STAFF REPORT 06-12-2024 REGULAR MEETING

APPLICATION NUMBER: HDC2024-00230

ADDRESS: 3515 BEAUBIEN

SCOPE: ERECT COMMERCIAL BUILDING

Design as originally proposed to LPD and PDD.

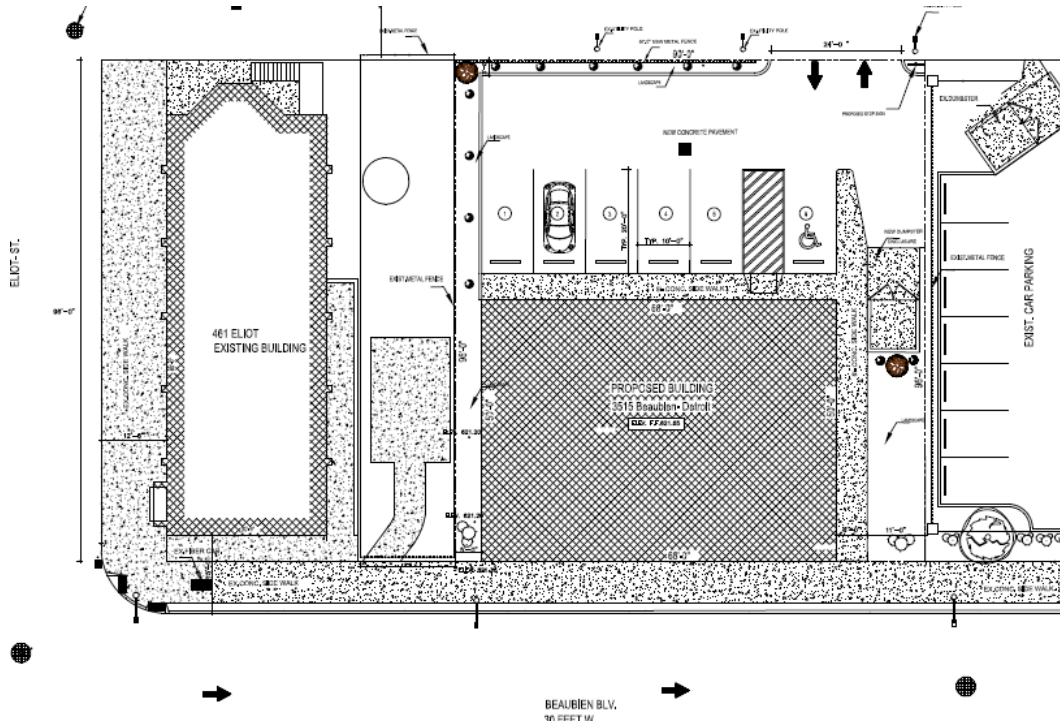
- This project was first introduced over the winter to the city with the design below. HDC staff, along with PDD-Design Review and CPC staff (Planners in the Legislative Policy Division), met with the applicant on two occasions to suggest changes that would better conform to the neighborhood’s form-based code and other restrictions including the district’s Elements of Design highlighted above. Improvements made to the design include vertically oriented windows, elimination of false/exaggerated “historic” features, transforming the sign into a proper canopy, and cleaner lines overall. Access and parking revisions were also made, eliminating a curb cut from Beaubien. While the revised building design is still horizontally oriented, staff does not assess that it is incompatible (and thus inappropriate), for this isolated location in the district, noting that less distinguished single-story buildings occupied this remote block historically. The design also shares a vocabulary with the previously approved medical office building across the alley, and builds density.
